# CITA comment on GTR 22

Proposal for a technical review on the development of a new global technical regulation on In-Vehicle Battery Durability for Electrified Vehicles

EVE 57<sup>th</sup> Session  
Brussels, Sept. 21, 2022

### Definition of Families

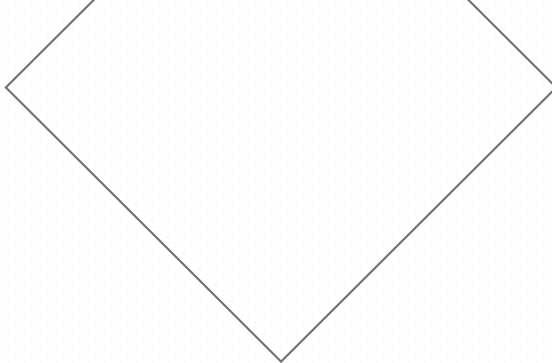
- Comprehensive formation of vehicle families
  - ➔ Linking of the definition of criteria to type approval / Test processes
    - Creation of database
    - Clear process description
    - Evaluation of the criteria

- Validation of the classification in vehicle family
- A defined family must be described precisely
  - ➔ Authorities or TS validation
- In consideration with UN-ECE Regulations
- Part A and B must be traceable in the information forms - Part A for ISC
- Part B => Verification via PTI
  - ➔ Capacity check as spot check
